From: Beggs, Tauren R - DNR
Sent: Monday, May 3, 2021 9:53 AM
To: Byers, Harris
Subject: RE: Update from River Point

From: Byers, Harris <Harris.Byers@stantec.com>
Sent: Friday, April 30, 2021 8:30 AM
To: Beggs, Tauren R - DNR <Tauren.Beggs@wisconsin.gov>
Subject: Update from River Point

Figure No.
5
 Title
Soil and Groundwater Sample Locations - August 2020

Client/Project
 Riverpoint District Site 1
 200 North 10th Street
 City of Manitowoc

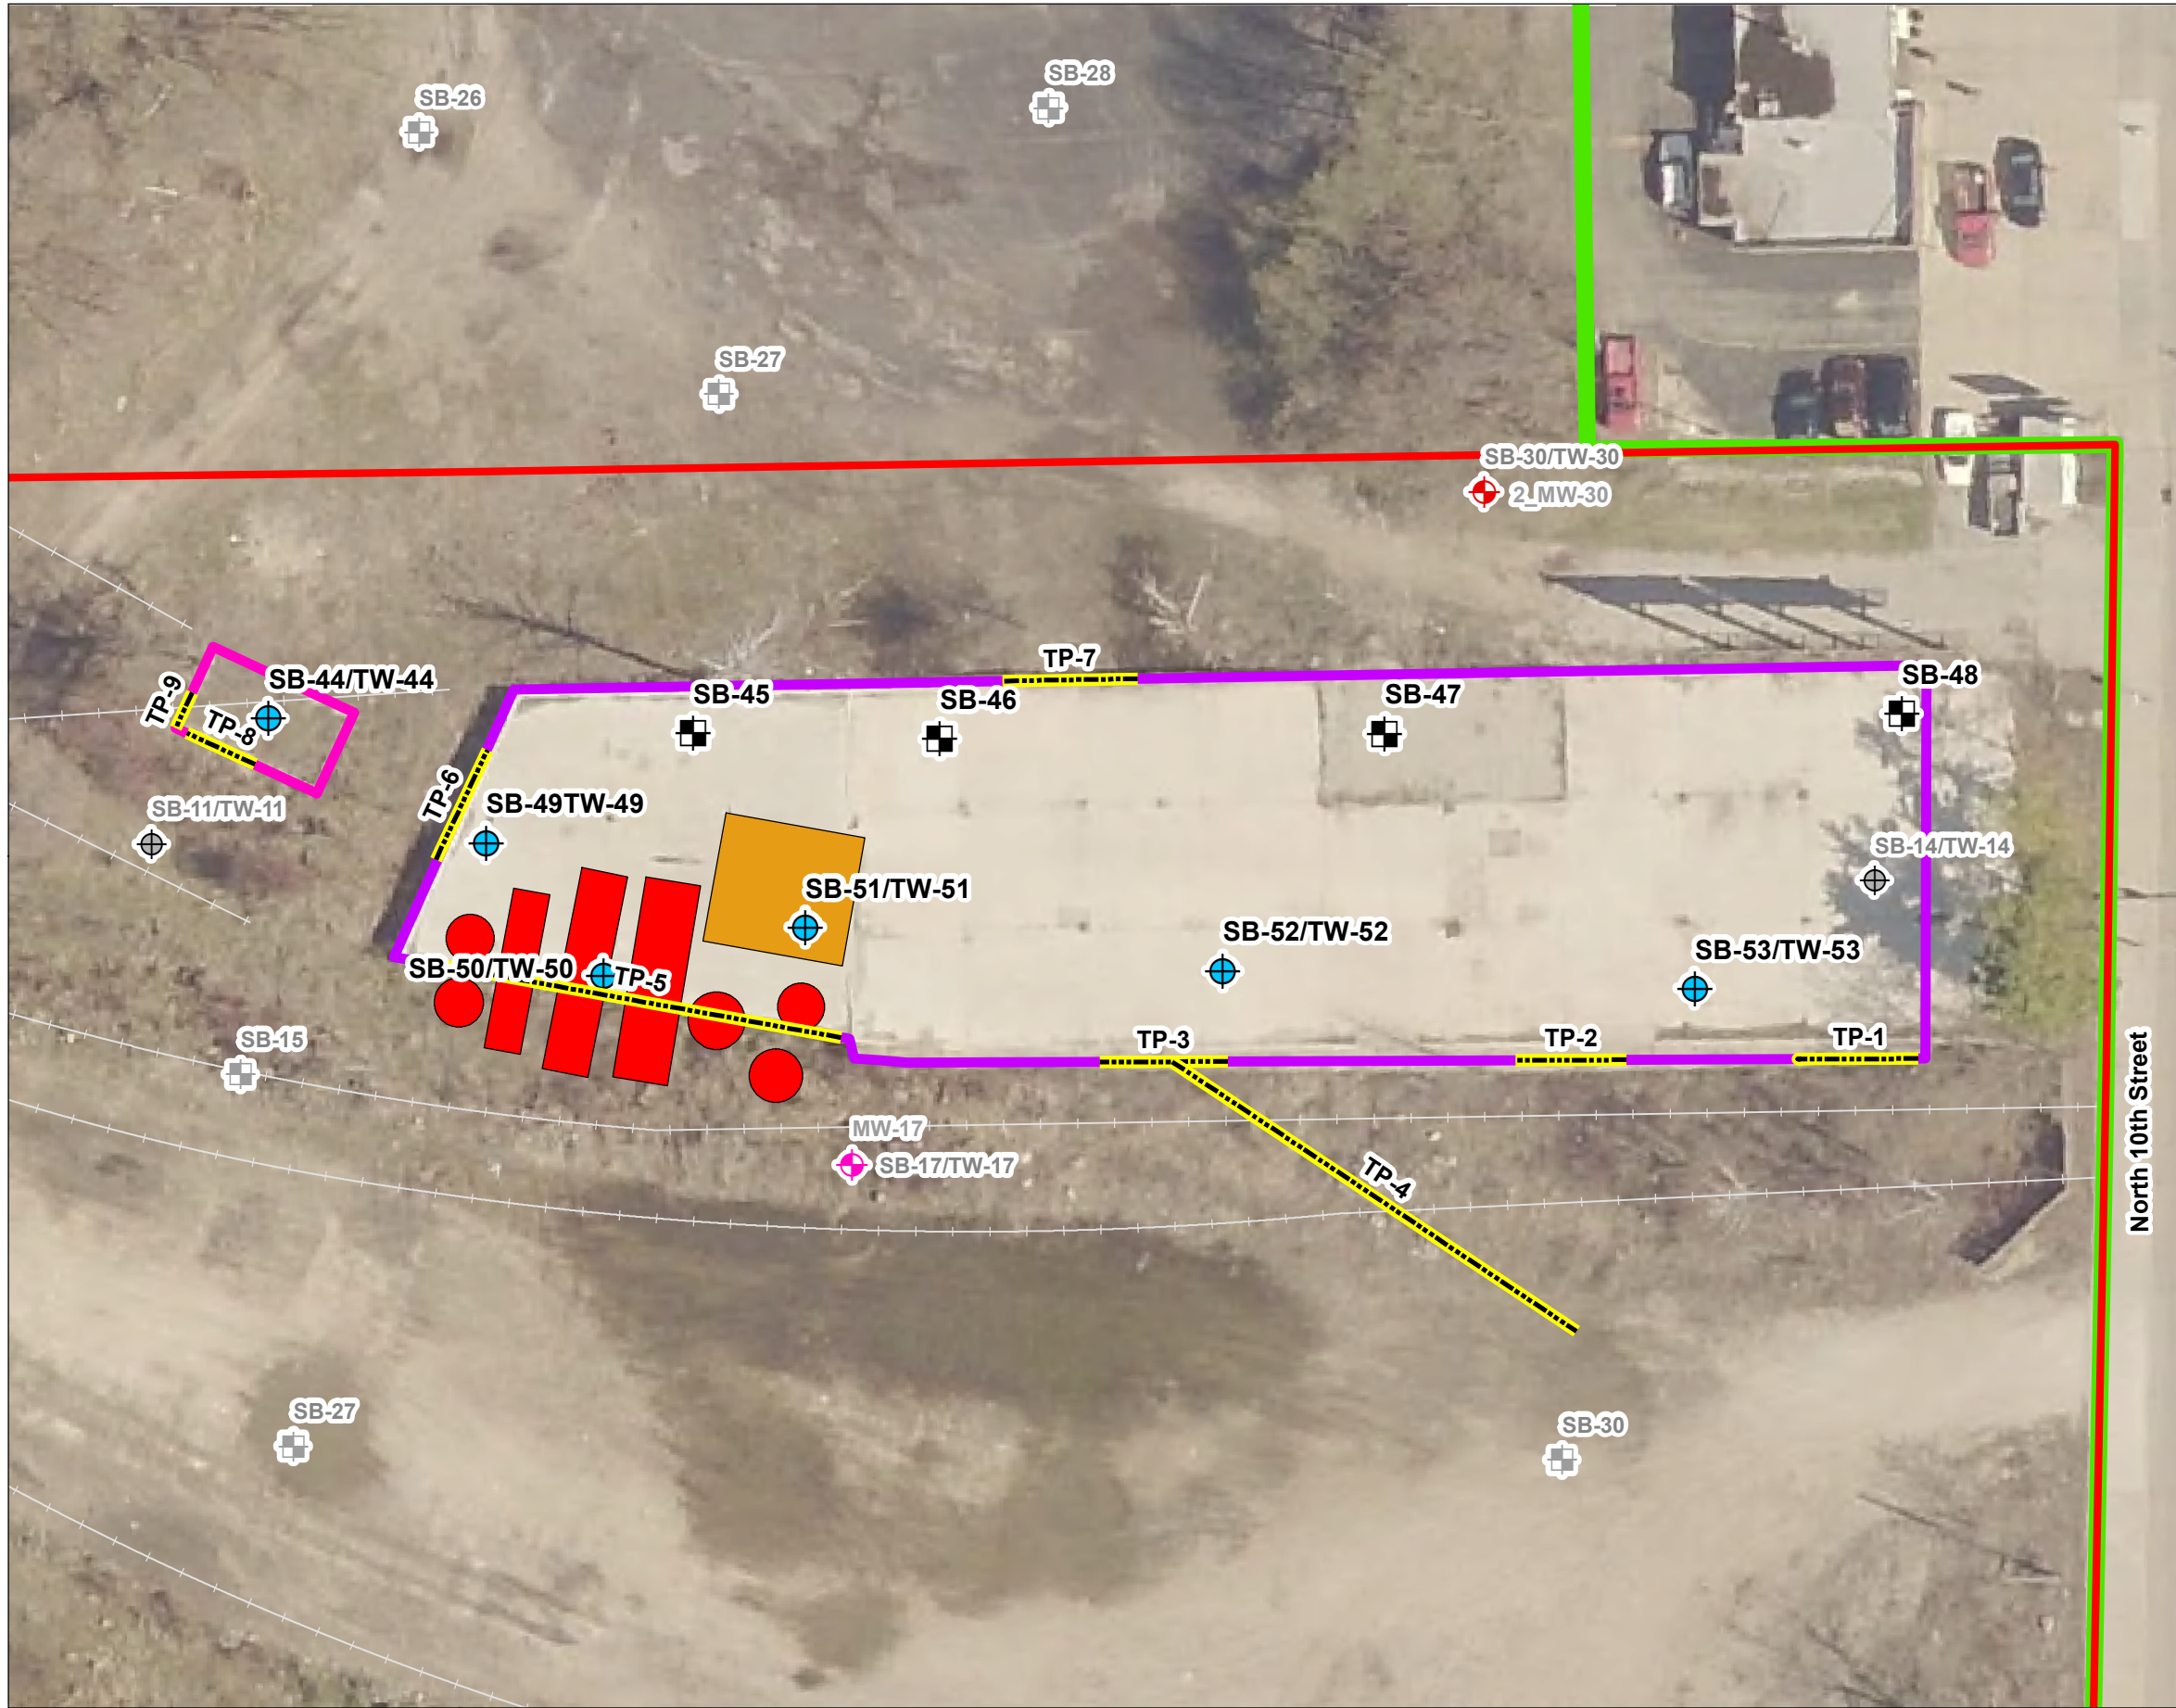
As part of initial Site prep work, the City's contractor was digging a few trenches and encountered petroleum impacted soil in the former bulk petroleum area beneath the former warehouse slab. Say south of TP-7 and north of SB-51 (see attached from Phase II ESA). The soil impacts are highly weathered with individual COCs generally meeting direct contact SROs. However, a very distinct petroleum odor still exists. To that end, I'm not comfortable reusing this soil onsite – so it seems reasonable to send this material to WM for their biopile, unless you think otherwise.

Yes, I agree it should be taken to a landfill as DNR doesn't normally allow VOCs to be reused on-site and it would have to get a materials management plan approval if you did want to reuse it on-site.
